Docket Number:	15-AFC-01
Project Title:	Puente Power Project
TN #:	212637
Document Title:	City of Oxnard's Comments on Ventura County APCD's Preliminary Determination of Compliance-Puente Power Plant
Description:	N/A
Filer:	Patty Paul
Organization:	Shute, Mihaly & Weinberger LLP/Edward T. Schexnayder for City of Oxnard
Submitter Role:	Intervenor
Submission Date:	8/5/2016 8:54:50 AM
Docketed Date:	8/5/2016

Re: City of Oxnard's Comments on Ventura County APCD's Preliminary Determination of Compliance-Puente Power Plant

Comments
on the
Puente Power Project
Ventura County APCD
Preliminary Determination of Compliance
and
California Energy Commission
Revised Preliminary Staff Assessment

Figure 1: Comparison of PM_{2.5} as Reported in AP-42 with Recent Measurements Using Improved Testing Methods.⁵²

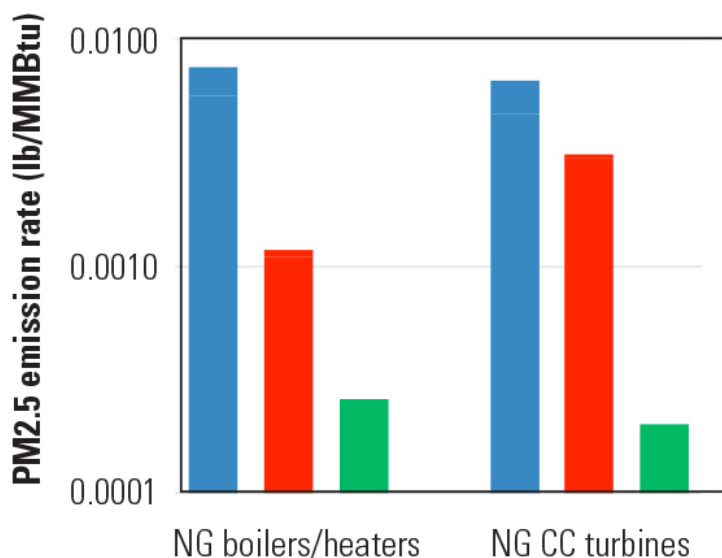
Figure 1 compares the results of these studies with AP-42 emission factors, relied on by the Applicant to establish the baseline. This figure shows that AP-42 emission factors

overestimate actual baseline emissions by significant amounts compared to modern testing methods.

The results of these investigations for gas-fired boilers and steam generators, such as MGS Unit 2, are summarized in Table 3. These revised emission factors have been used in EPA National Emission Inventories and to permit new sources.⁵³ The revised PM_{2.5} emission factor for gas-fired boilers and steam generators (0.35 lb/MMscf⁵⁴) is a factor of seven lower than the AP-42 emission factor of 2.5 lb/MMscf used in the Applicant's PM_{2.5} netting analysis.⁵⁵ Using

this revised PM2.5 emission factor but otherwise using the Applicant’s assumptions, yields a net change in PM2.5 emission of **10.4 ton/yr**.⁵⁶ This change alone results in an exceedance of the PM2.5 significance threshold and triggers PSD review for PM2.5.

Figure 2: Monthly NOx and Fuel Use 2009-2014
(gas flow units in 100 scf/mo)

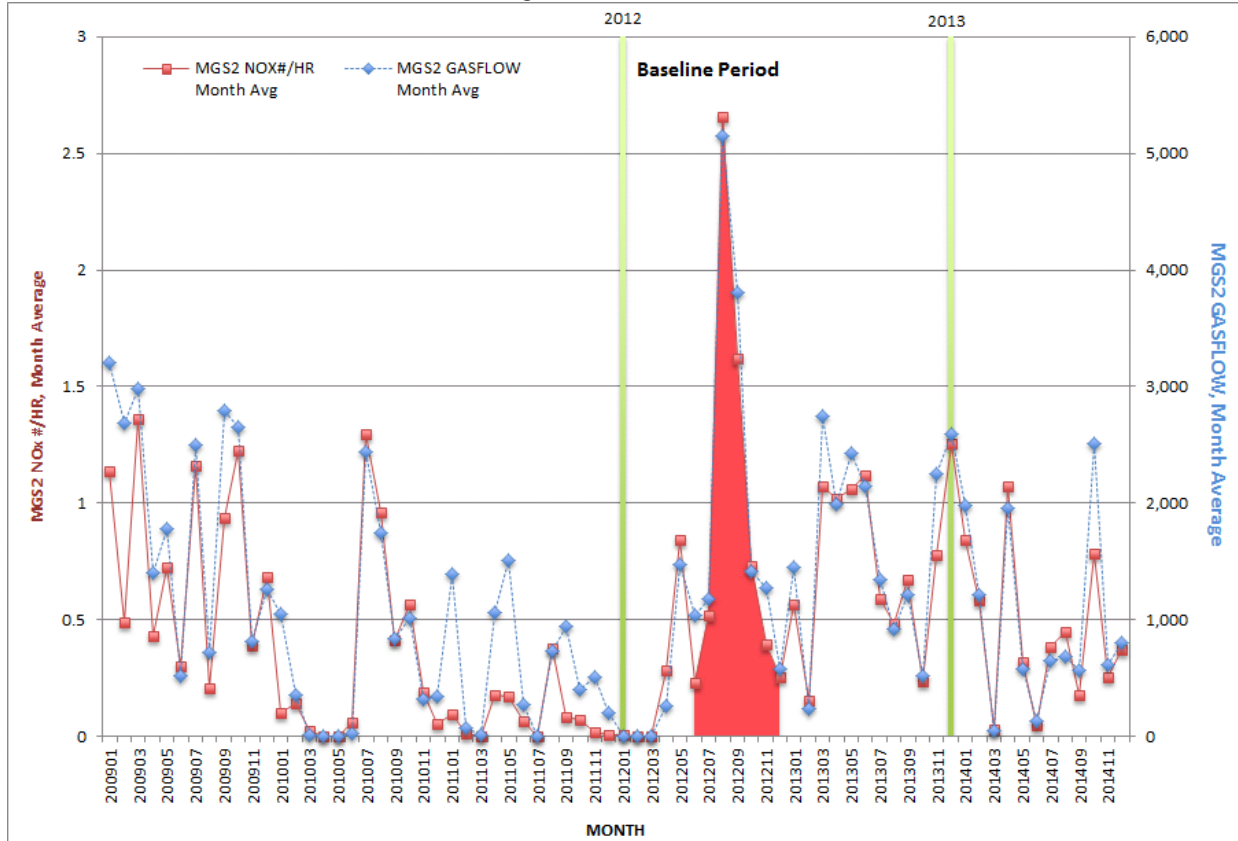
My analysis of the applicant’s NO_x and fuel use CEMS data, summarized in Figure 2, indicates that the 2012-2013 period selected as the baseline is not representative of normal

operation. In fact, it is the two year period that yields the highest baseline emissions for all pollutants, rather than representative baseline emissions.

First, the 2012-2013 period includes a very large spike in August and September of 2012.⁶⁵ A similar spike is not found elsewhere in the record.

Second, my analysis of this data, summarized in Table 4, indicates that the Applicant picked the two year period that yields the lowest net change in PM2.5 emissions from among the four possible consecutive two-year combinations (10.0, 9.63, **9.06**, 9.27 ton/yr). It is not apparent how a spike in fuel use and emissions, including many violations of permit limits⁶⁶ as discussed in Comment section II.B.2.c.ii satisfies VCAPCD Rule 26.6C.

Figure 3. Hourly PM_{2.5} Emissions from MGS Unit 2.⁷¹

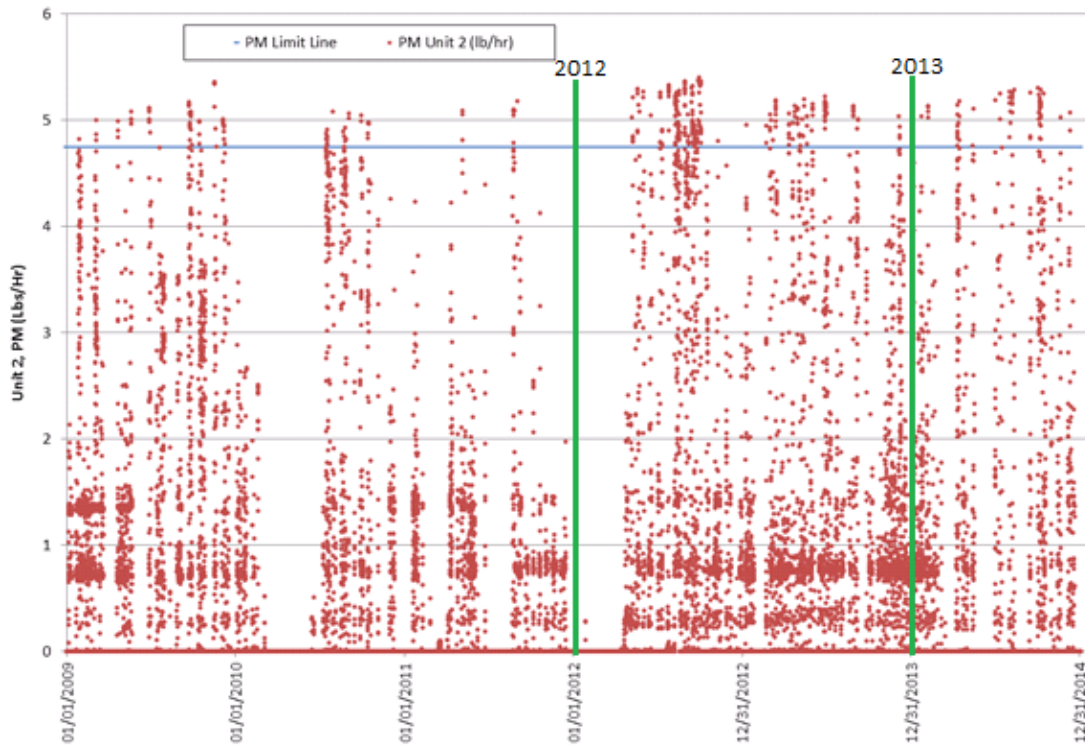
⁷⁰ In the two years from 2012 – 2013, Unit 2 operated 11,187 hours. There were 452 PM violations (PM>4.74 lb/day) during 2012 -2013. Because each violation accounts for one hour, 452 hr / 11,187 hr = .0404, which rounds to 4%.

Figure 4. Hourly Gas Flow for MGS Unit 2.

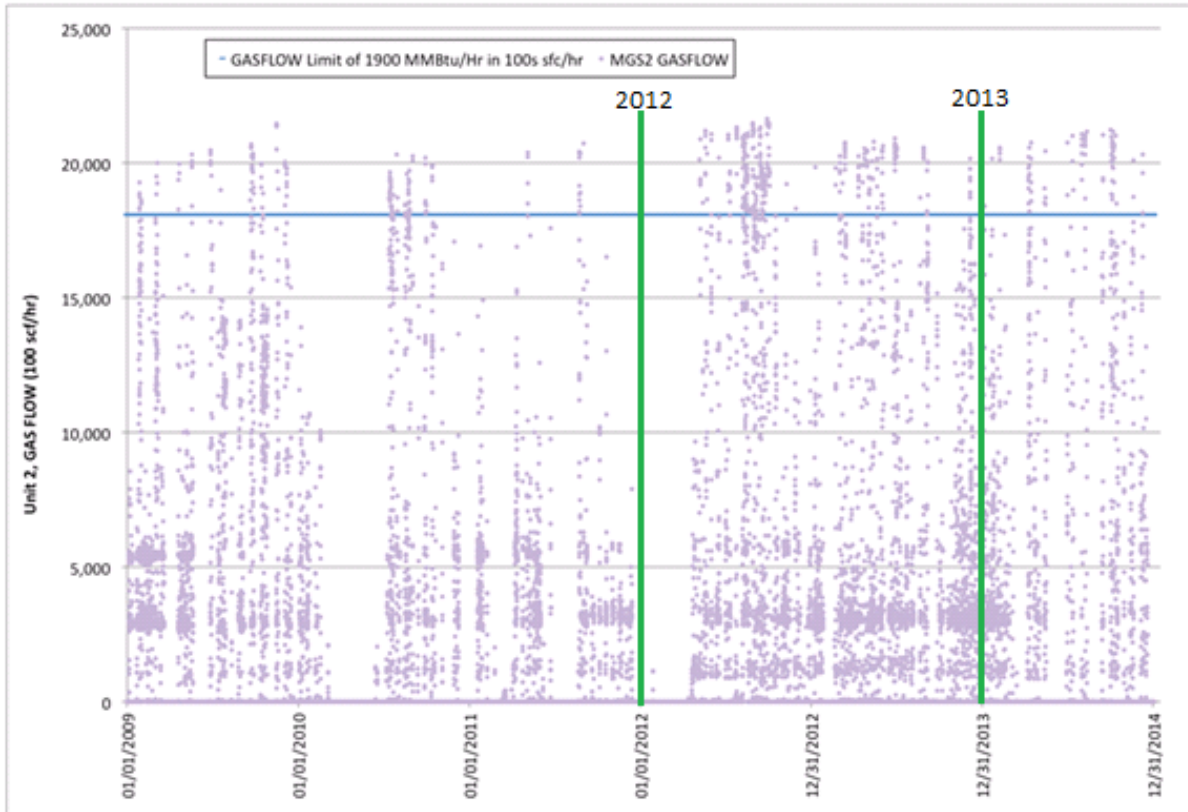
Further, MGS Unit 2 is permitted as a Babcock & Wilcox natural gas steam generator with a maximum heat input of 1990 MMBtu/hr.⁷² The Applicant's CEMS data also indicates that the unit operated at higher maximum heat inputs during the baseline period.

⁷² VCAPCD Permit, Table 4 provides that: $(1900E+6 \text{ Btu/hr}) / (100 * 1050 \text{ Btu/scf}) = 18,095$ hundreds of scf/hr, assuming a maximum higher heating value (HHV) of the natural gas of 1050 BTU/scf and fuel use reported in 100 scf, as provided by the Applicant.
